London Luton Airport Expansion

8.68 Applicant's response to Written Questions - Biodiversity

**8.68 APPLICANT'S RESPONSE TO WRITTEN QUESTIONS -
BIODIVERSITY**

Deadline:	Deadline 5
Planning Inspectorate Scheme Reference:	TR020001
Document Reference:	TR020001/APP/8.68
Author:	Luton Rising

Drawing Title
Applicants response to ExA Written Question BIO.1.1:
Orchid Location Plan

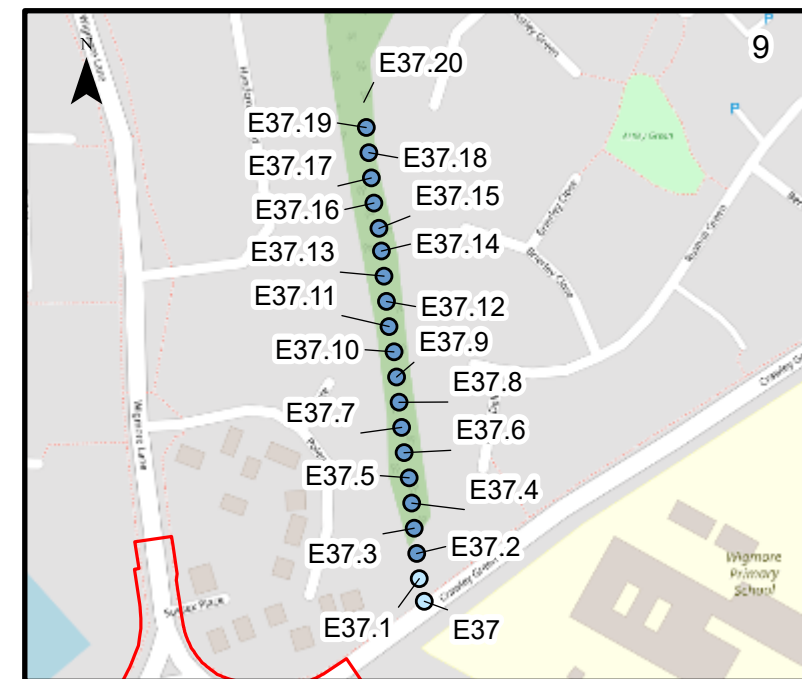
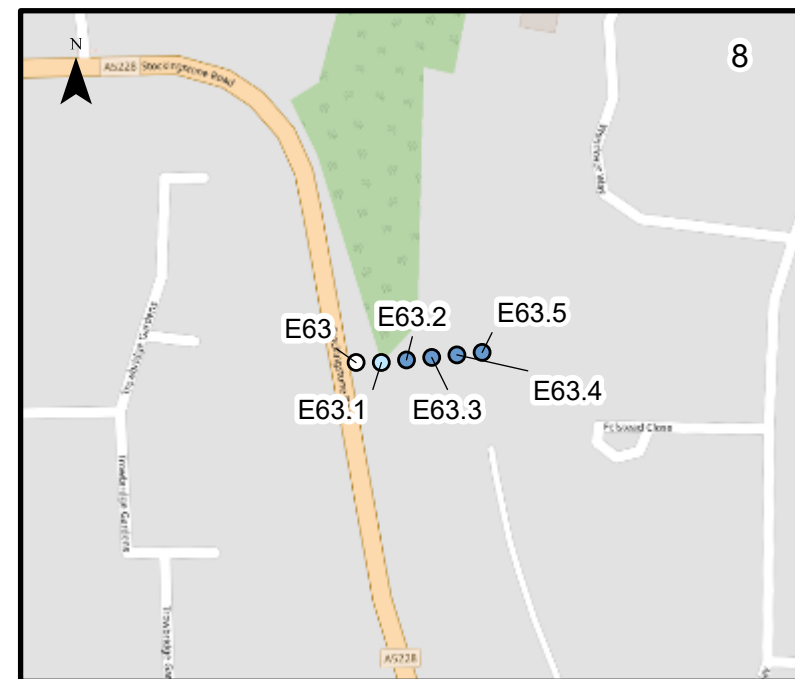
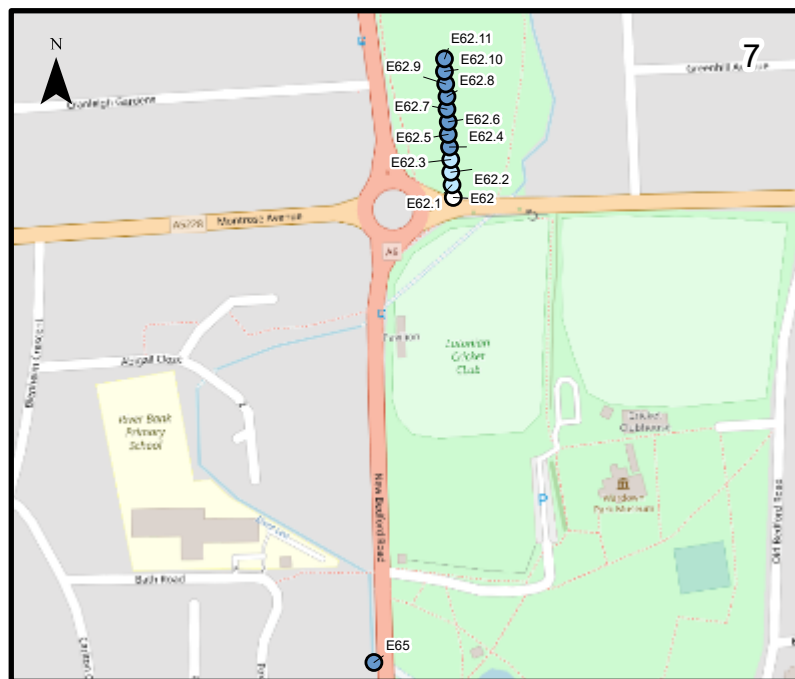
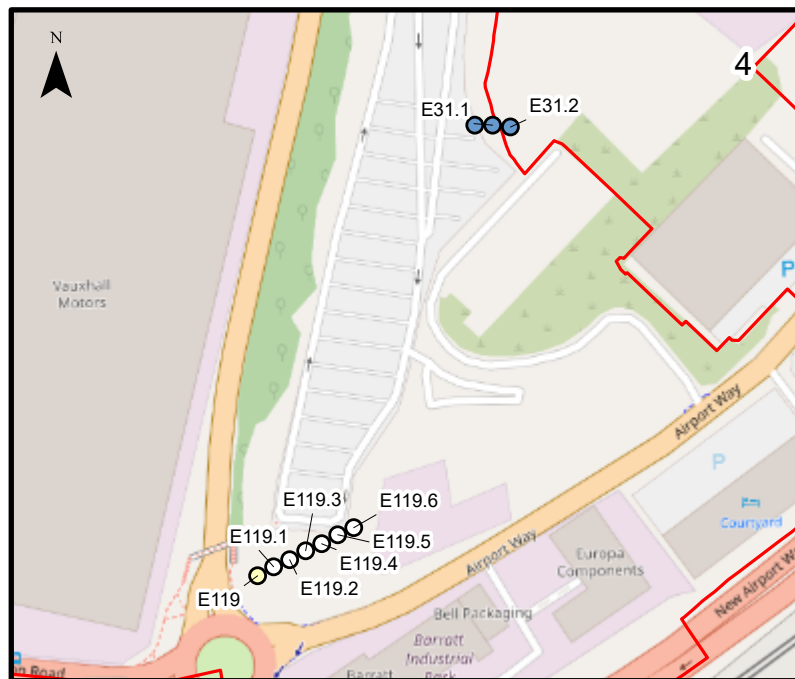
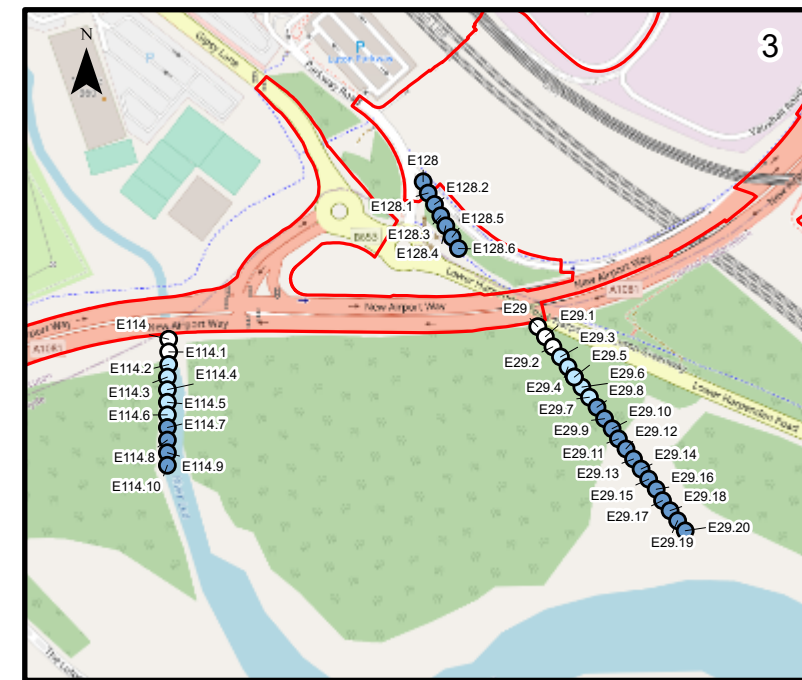
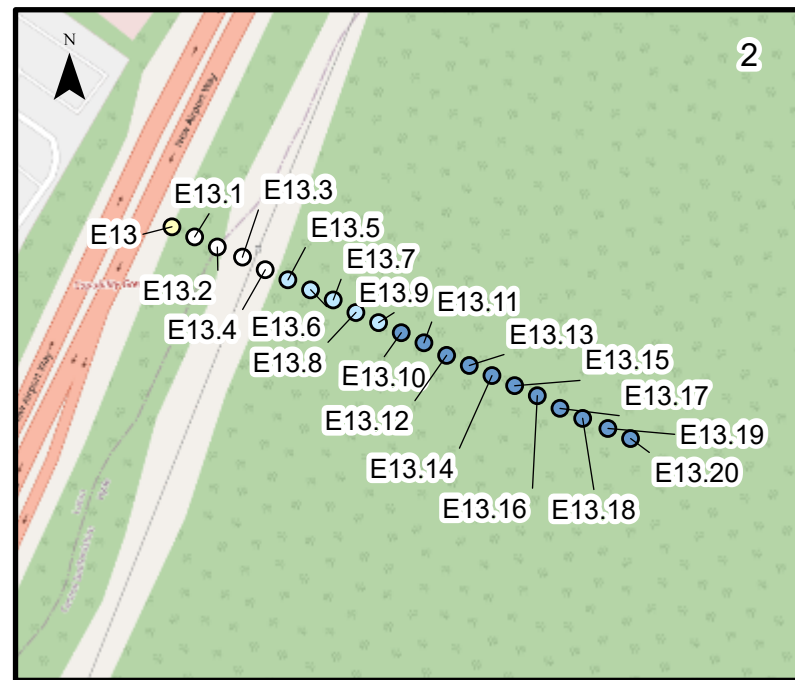
PINS ID	Question / Response
BIO.1.1	<p>Question:</p> <p>Orchids</p> <p>The mitigation strategy for orchids [AS-035] relies in part on an existing orchid population beyond Wigmore Valley Park County Wildlife Site. It is not clear from the information provided [AS-033 and AS034] where existing stands of orchids across the site are located. Please provide this information in a level of detail sufficient to inform a site inspection.</p> <p>At ISH6 and in the Applicant's response at D3 [REP3-053] it is stated that <i>"there have been many examples of natural colonisation [of orchids] occurring very quickly in close proximity to the proposed site"</i>. Provide the evidence to support this statement.</p> <p>Response:</p> <p>Please see an additional Figure created in response to this question, which is included as Appendix A, that shows the location of all orchids identified during baseline surveys for the Proposed Development. It should be noted that in some locations, such as grassland 5 north of Winch Hill Wood, orchids were very frequent (around 200 common spotted orchids noted) and growing widely in the open sward. Thus, precise location of individual plants is not provided, rather associated habitat parcels are indicated. Further details of these results are provided on pages 9 and 10 of the Appendix 8.10 Ecological Mitigation Strategy Orchid and Invertebrates [AS-035] and within Appendix 8.1 Ecology Baseline Report of the ES [AS-033].</p> <p>Regarding the comments made around local orchid colonisation, at ISH6 these were made primarily in reference to the species noted during baseline surveys for the Proposed Development, including the common spotted orchid colony in grassland 5. Section 2.6.177 of the Ecology Baseline Report [AS-033] reports Grassland 5 has also been taken out of agricultural use and has been colonised by a range of agricultural associated species with patches of bare ground, including the orchids.</p>

PINS ID	Question / Response
	<p>Additionally, the lead biodiversity witness for the Applicant (Dr Paul Clack) formerly worked for the Herts and Middlesex Wildlife Trust. This included management experience at local nature reserves. The Trust manages Hexton Chalk Pit, around 5km north of Luton Airport. This is a site where various orchid species including those found within the Wigmore Park County Wildlife Site (CWS) have colonised a former active chalk quarry, with young plants frequently found on the thin exposed soils. Additionally, common spotted orchid colonised exposed chalky gravels at Stocker's Lake, also managed by the Herts and Middlesex Wildlife Trust.</p> <p>Harrop and Harrop (2005)¹ report that pyramidal orchid takes readily to man-made habitats, including abandoned industrial sites and disused quarries, and is one of the first orchids to move into such newly created habitats. They also report that bee orchids occur on similar sites as pioneer species and behave <i>"...like 'weeds', colonising areas of bare or disturbed ground. They increase rapidly in numbers until a closed sward develops and then, being 'poor' competitors, they disappear."</i> They also report that this species is tolerant of heavy grazing and trampling.</p> <p>Orchids within the CWS are assumed to have colonised naturally on the former landfill site from wind-blown seed from the wider area. It should be noted that within Section 4 of Appendix AA to the Ecology Baseline Report [AS-035] it was noted that the lack of regular livestock grazing at Wigmore Park means that Bramble and expanding rhizomatous patches of introduced Michaelmas-daisy are, and will continue to be, a threat to the extent and quality of herb-rich neutral and calcareous vegetation.</p> <p>The Applicant has control over land in the new open-space and the ability to specifically manage newly created, enhanced and retained habitats for orchids and other species. Through the detailed design stage, final habitat management prescriptions will be refined and further input from LBC and HCC ecologists will be welcomed. Paragraph 10, sub paragraph 1, of Part 2 of Schedule 2 of the draft DCO [REP3-004] includes a suitable control measure, making provision for the landscape and biodiversity management plan to be approved by the relevant planning authorities.</p> <p>There is opportunity to review seed sources and mixes through the detailed design stage. Although not currently proposed, seed from orchids including common spotted and pyramidal orchid can be included in bespoke seed mixes and is available from seed merchants. Orchid seeds are very small and light, and such seed does not form significant percentages in proprietary mixes but could be added into the mix to be sown in discrete locations if required.</p>

Drawing Title
 Applicant's Response to ExA Written Question BIO.1.3:
 Modelled ecological receptors (nitrogen deposition results)
 Assessment Phase 1
 Page 1 of 2

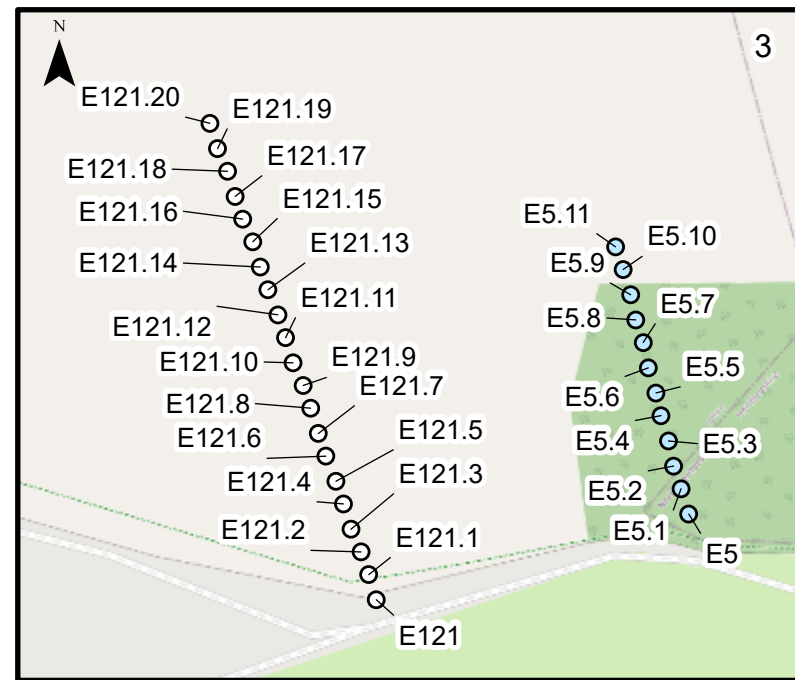
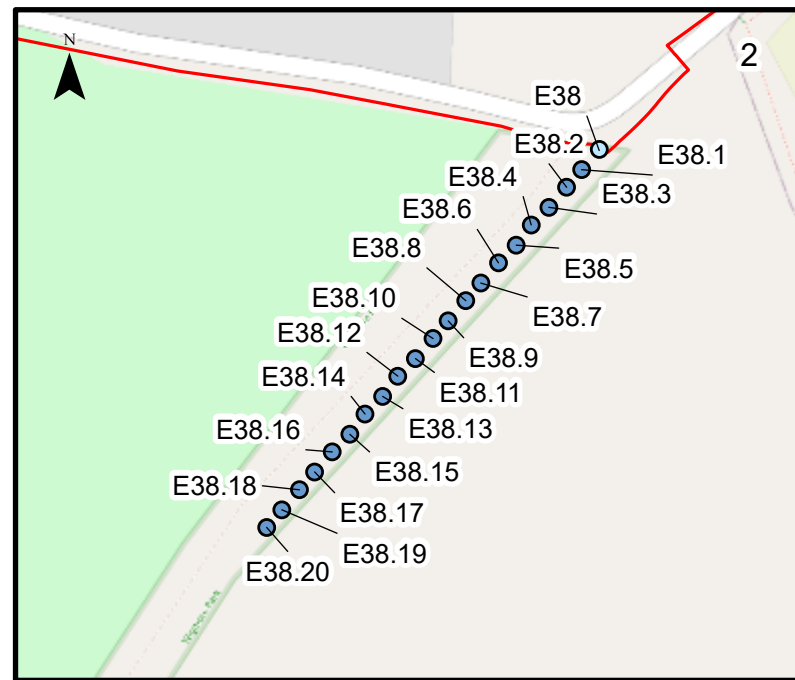
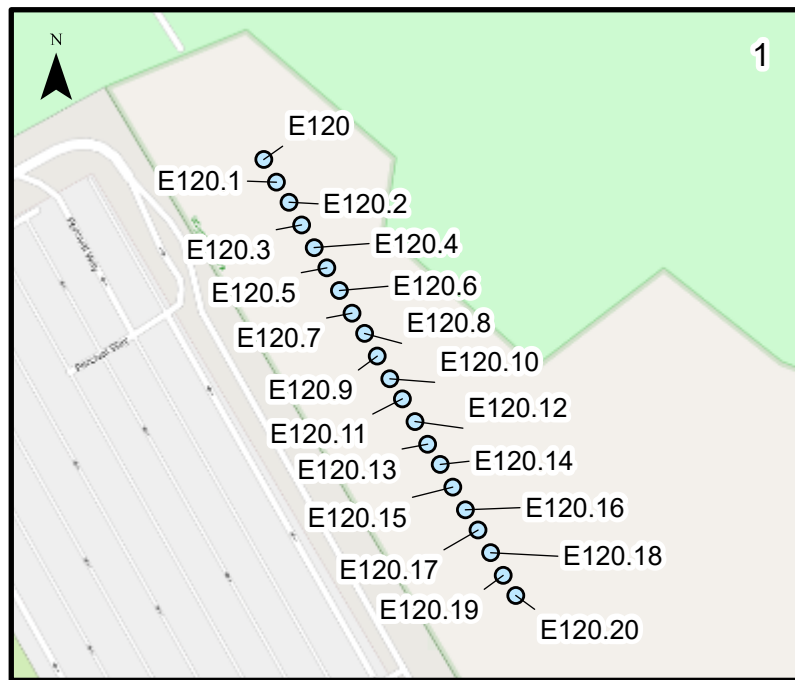
BIO.1.3	<p>Question: Nitrogen deposition At ISH6 and in the Applicant's response at Deadline 3 [REP3-053, paragraph 3.1.19] it is stated that agriculture is a significant source of nitrogen and that the proposed removal of land from agricultural production would counterbalance the modelled nitrogen deposition on protected habitats and species.</p> <ol style="list-style-type: none"> 1. Provide an assessment, ideally quantitative, of the anticipated reduction in nitrogen deposition from removal of agriculture and the associated timescales for this. 2. Provide the equivalent assessment of the anticipated reduction in nitrogen deposition from the shift to electric vehicles referred to in [REP3-053, paragraph 3.1.21]. <p>The results of the air quality modelling in Appendix 7.3 [APP-063] and mapping of these [AS-099] are noted. However, the plans are not clear in respect of ecological receptors because cross-referencing is still required with the results tables. Please provide clear illustrations for the different phases of modelling of:</p>

PINS ID	Question / Response
	<p>3. Exceedances of the mean NOx critical level and contribution of the Proposed Development to this, highlighting where it is more than 1% [APP-053, Table 3.37].</p> <p>4. Exceedances of a 1% increase in nitrogen deposition and the change against the lower critical load [APP-053, Table 3.38].</p> <p>5. These should be provided on a background map and scale to clearly illustrate the effects on identified ecological receptors.</p> <p>Table 3.3 [AS-028] sets out the location of sensitive ecological receptors, including transect locations, which are illustrated in Figure 7.3b [AS-099]. It is noted that transects are not shown for (at least) receptors E10, 31, 37, 39, 48, 63, 64, 65, 114, 119, 120 and 121. Receptor locations and transect locations are missing for (at least) E123, 124, 125, 127, 128 and 129.</p> <p>6. Provide an updated Figure 7.3b showing the location of missing receptors/ transects and confirm that no other receptor locations are missing. Transect sub-numbering e.g. E120.x should also be provided.</p> <p>Response: Question 1</p> <p>For clarity, the Applicant did not say that removing land from agricultural production would counter-balance the impacts of the Proposed Development, if 'counterbalance' is interpreted as meaning 'entirely offset'. At ISH6 the Applicant stated that they did not believe the benefit of the removal of land from agricultural production could be quantified (hence no quantification is presented in Chapter 8 of the ES [AS-027]). However, the Applicant noted (in ISH6 and in the ISH6 Post Hearing Submission [REP3-053] and in Chapter 8 of the ES [AS-027]) that agriculture is a significant source of atmospheric nitrogen at all the modelled sites. This can be verified by using the Site Relevant Critical Load App on the APIS website (https://www.apis.ac.uk/app), entering the coordinates for each designated site, selecting 'results' on the left hand menu and then selecting the 'source attribution' tab and the 'local contributions to nitrogen deposition' pie chart. As examples:</p> <ul style="list-style-type: none"> • 29.2% of background nitrogen deposited in the 5km grid square in which Winch Hill Wood is situated derives from agriculture (livestock and fertiliser), compared to 36% from transport (road transport and 'other transport' i.e. the airport and the railway); • 21.6% of background nitrogen deposited in the 5km grid squares in which Burnt Wood, Stubbocks Wood, and Diamondend Springs, Limekiln Wood & Pondcroft are situated derives from agriculture, compared to 25.3% from transport;
